TECHNICAL INFORMATION #940

Re: Improvement modification of the IC-2720H/2725E

Model: IC-2720H/2725E (All versions)

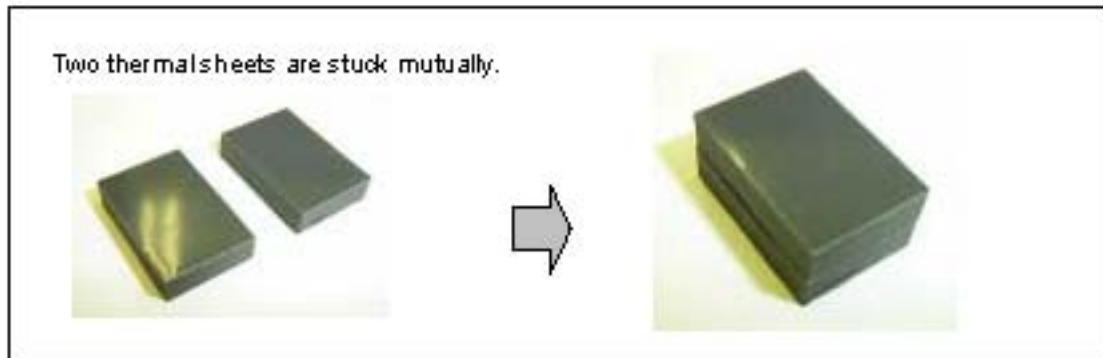
Around the VHF antenna filter parts on the main board will be damaged when transceiver is using in high temperature environment.

The antenna switch diodes have over heated. It is caused by resistance of the forward direction of the antenna switch diodes are out of specification.

By replacing R102, a supplied bias current to antenna switching diodes is increased and this reduces the forward direction resistance of these diodes to prevent self overheat.

Board	Parts Number	Parts Number(Old)	Parts Number(New)	Action Taken
MAIN	R102	7030006070	7030008350	Replaced
		100 ERJ12	39 ERJ12	
MAIN	MP20	None	8930052930	Add 2pcs of thermally sheets
			THERMALLY SHEET(P)
